STATE OF WASHINGTON
DEPARTMENT OF ECOLOGY

June 1, 1992

Re: CONTINGENCY PLANNING AND CORRECTIVE ACTIONS FOR SINGLE SHELL
TANK 241-C-106

COMPARISON OF EVAPORATIVE LOSSES AND WATER ADDITIONS TO 106-C
May 27, 1992

Liquid Level in Tank 106-C

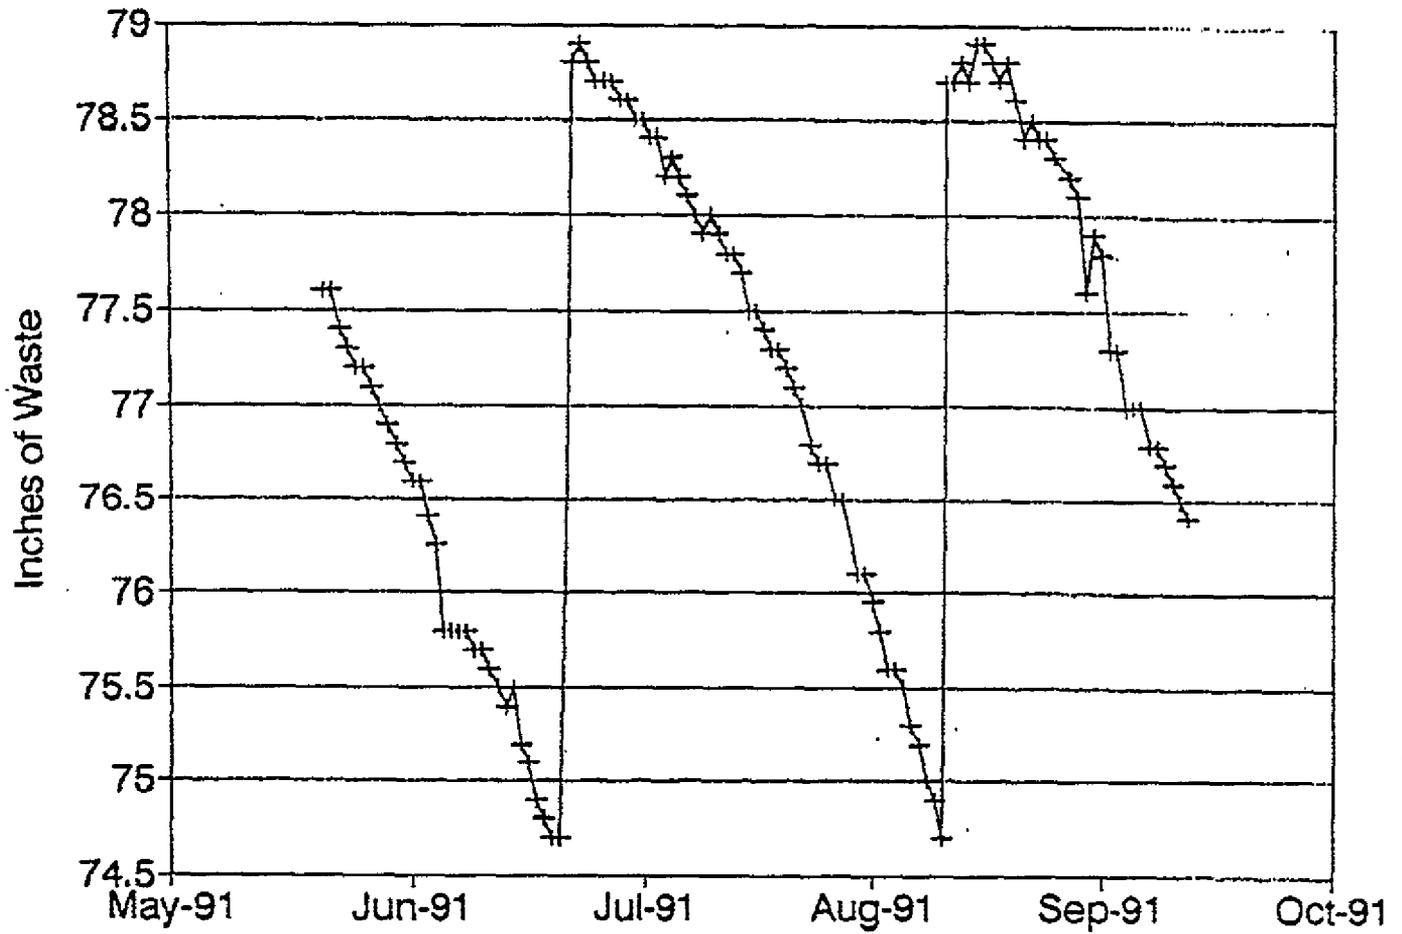
Liquid level measurements in tank 106-C show steady liquid surface decreases of about 230-270 gallons per day, interrupted every 4-8 weeks by batch additions of 6000-12000 gallons of water (see Figure 1). USDOE/WHC has proposed that these liquid level decreases are caused by the evaporation of water due to the high radioactive decay heat in this tank (waste temperatures were reported to be up to 188F on May 23, 1992). USDOE/WHC monitors the water content of air entering and exhausting from tank 106-C. These monthly measurements can be compared to the water addition records to provide indirect leak detection. The amount of water added to the tank should roughly equal the amount of water vapor released to the atmosphere. If not, 106-C may be leaking.

Figure A-3. Tank 106-C Vent System

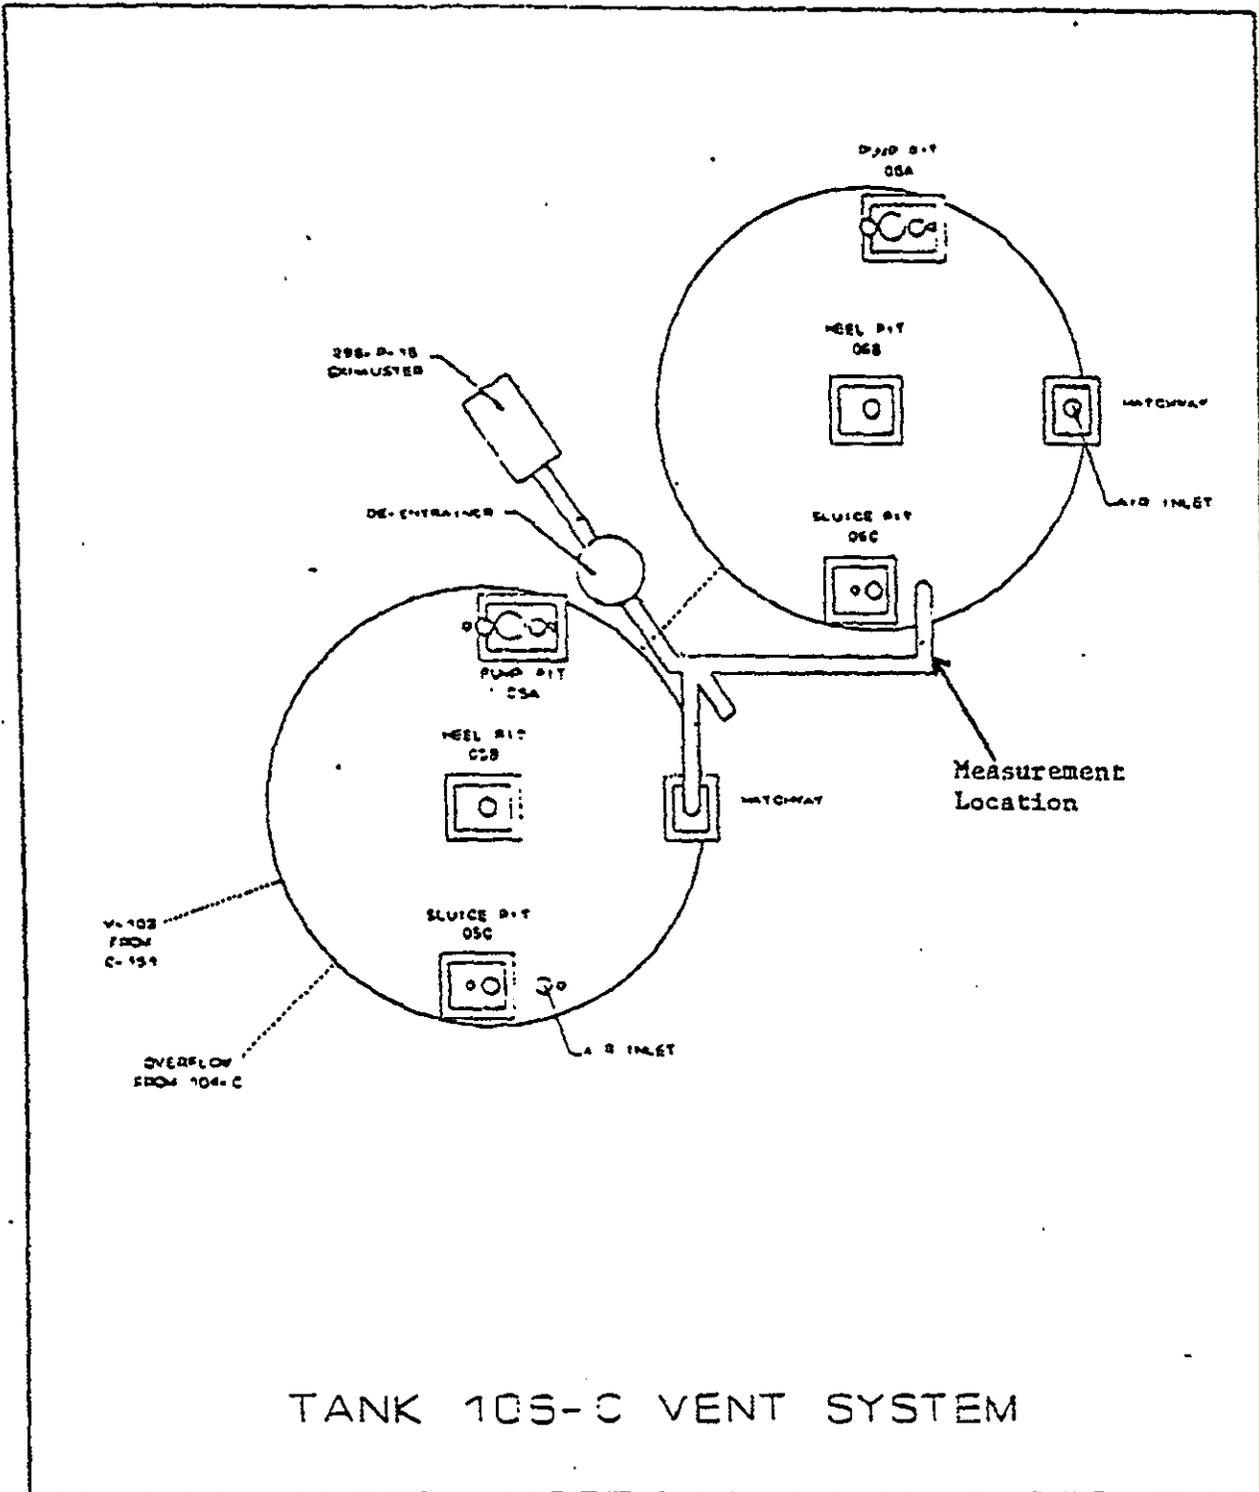
- Moist air from 104-C and 105-C enters 106-C through a 3 inch overflow pipe. In addition, condensed vapors from 105-C and 106-C are collected in a deentrainer and returned to 106-C. Both sources of water should be added to the water additions for 106-C. If this were done the discrepancy between water additions and evaporative losses would be greater. The volumes of these sources are not known, and should be measured if possible.

- The effect of the deentrainer on uncondensed vapors is not known. If the deentrainer is causing some water vapor to condense, this would cause evaporative losses to be overestimated (since evaporative losses are measured before the deentrainer) and would increase the observed discrepancy between water additions and evaporative losses.

Tank 106-C Water Balance

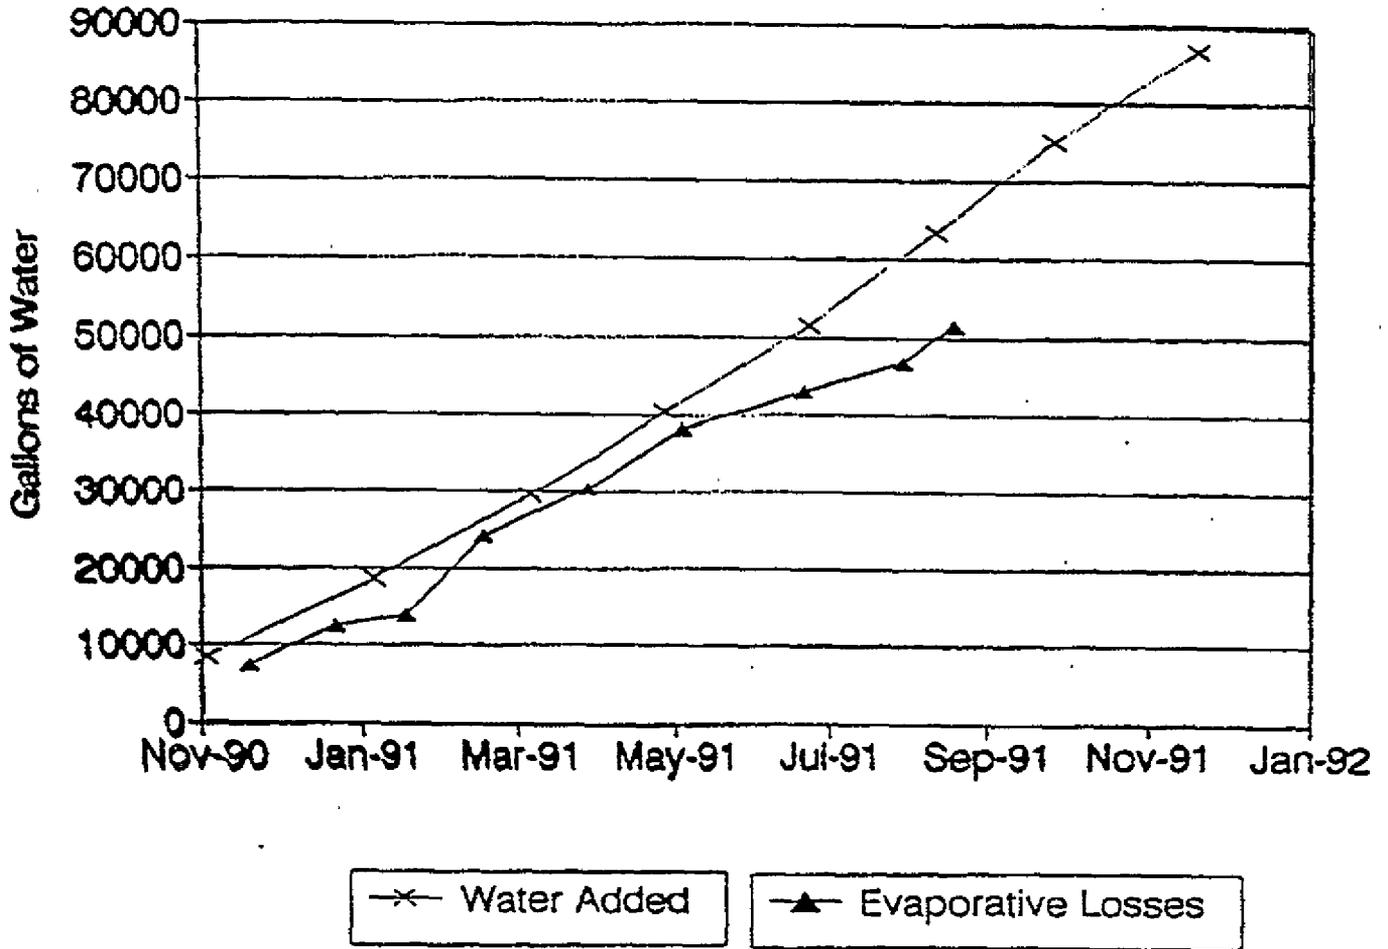
Figure 3 shows cumulative water additions and evaporative losses for November 1990 through December 1991 (Note: Water additions are plotted as a smooth curve though they actually occur in batches). The difference between these two curves indicates water added to the tank but not accounted for in the exhaust vapor. The two curves agree well until May through September 1991 (the last time exhaust vapor was measured) when this cumulative difference grew to about 10000 gallons (more water added to the tank than measured in the exhaust).

The 10000 gallons of unaccounted water may or may not be a significant discrepancy. Water addition data is thought to be very accurate, but calculations of evaporative losses have some unspecified uncertainty associated with them. The error range of the water vapor measurements has not been determined so it is not clear whether the 10000 gallon discrepancy is within measurement error, or whether it represents a leak from the tank.

Until these limitations are quantified (providing an error range for the measurement), or until other more sensitive leak detection methods are proven, a conservative approach would be to consider that 10000 gallons of tank liquids may have leaked from tank 106-C between May and September 1991.
